# ADDENDUM

ADDENDUM NO.: 01  
PROJECT NAME: DUNNE TECHNOLOGY ACADEMY MODERNIZATION – SCOPE B  
PROJECT NO.: 05440  
CONTRACT NO.: C1566a  
DATE OF ISSUE: May 1, 2015

## NOTICE OF CHANGES, MODIFICATIONS, OR CLARIFICATIONS TO CONTRACT DOCUMENTS

### SITE UTILIZATION PLAN – PHASING DIAGRAMS

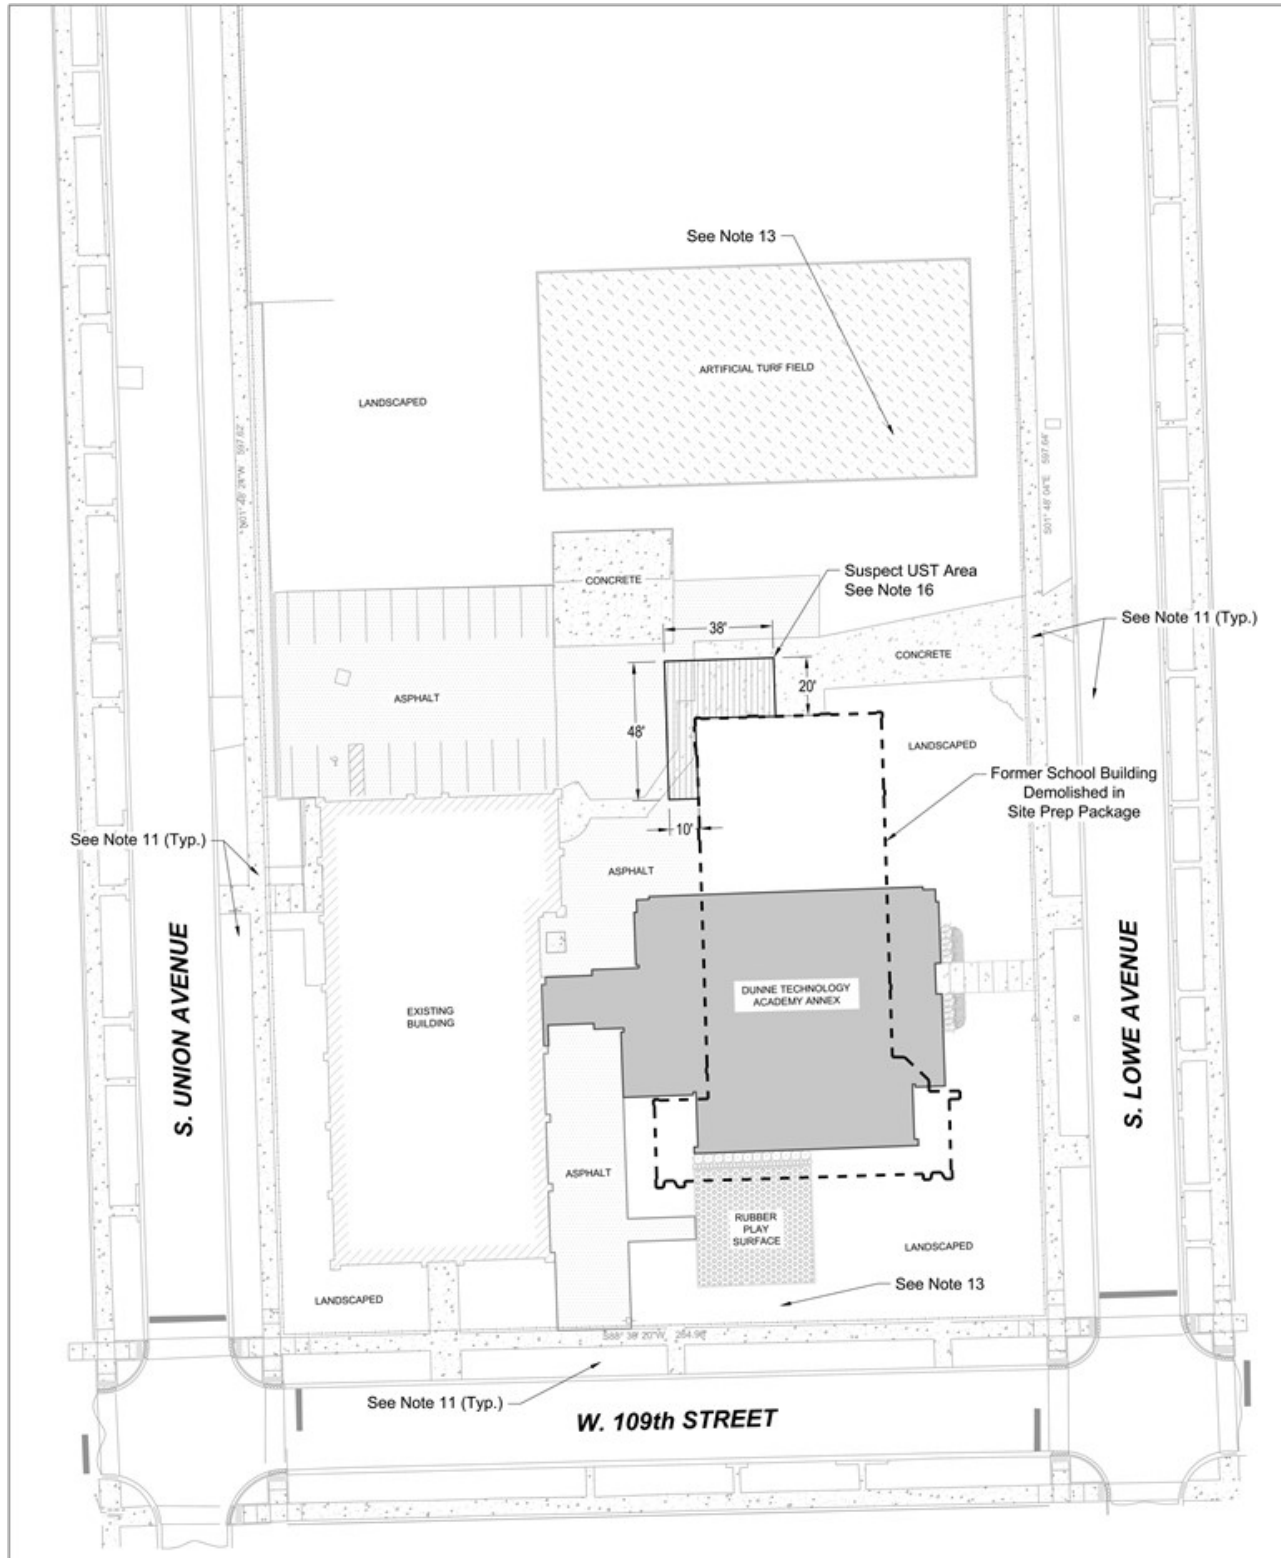
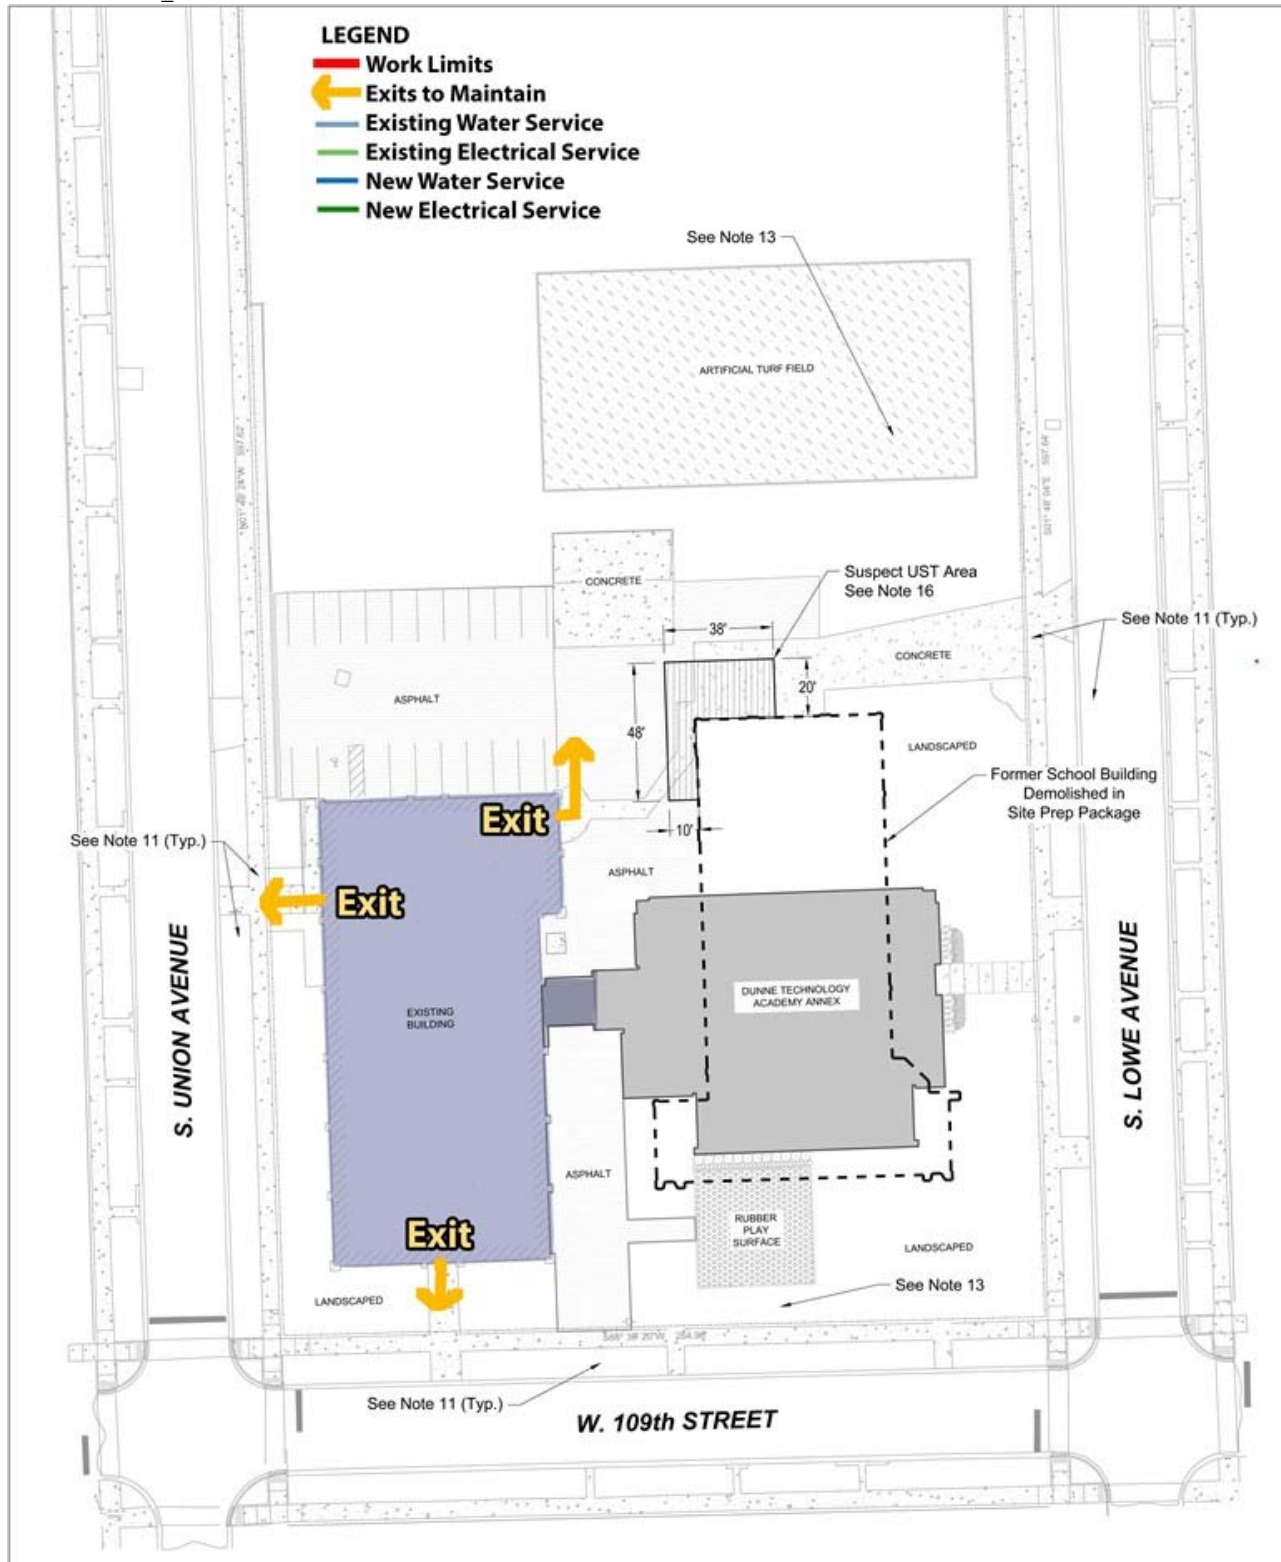
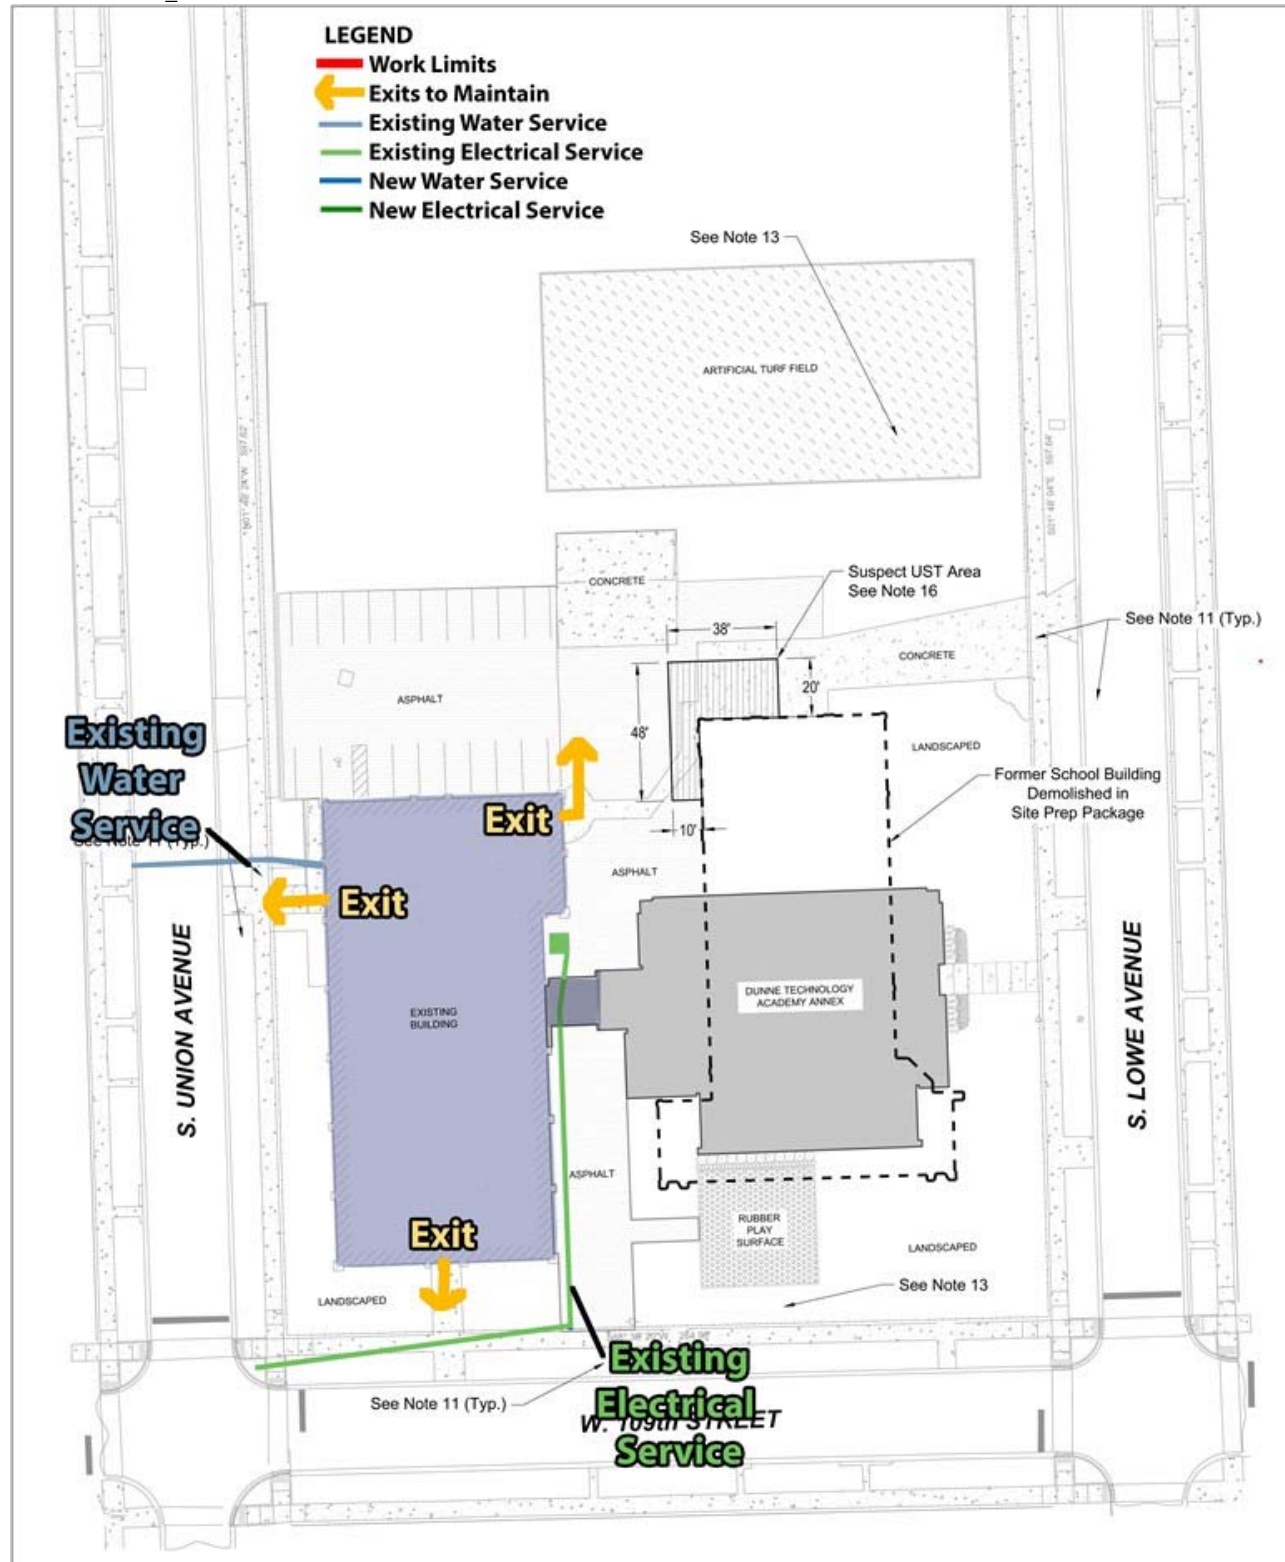
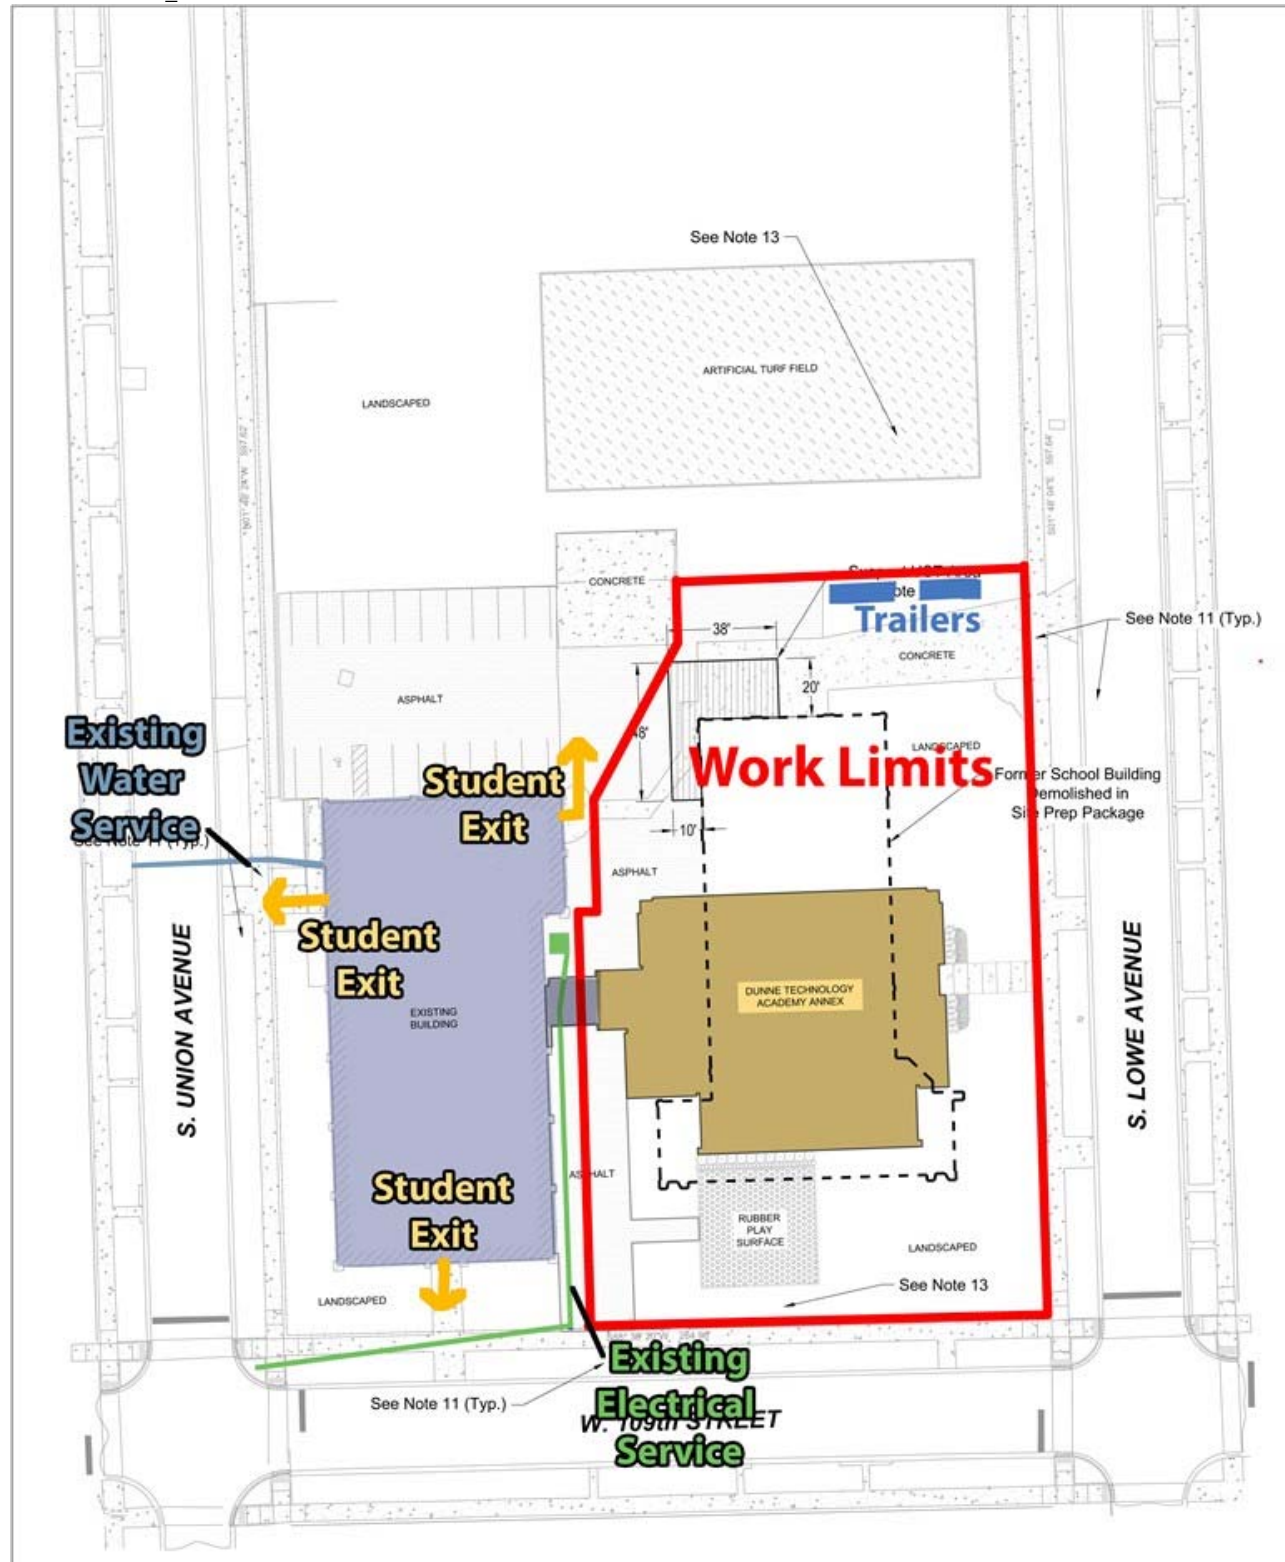
5. Specification 01 14 11A – SITE UTILIZATION PLAN – PHASING DIAGRAMS
  - a) Replace section in its entirety with revised section attached.
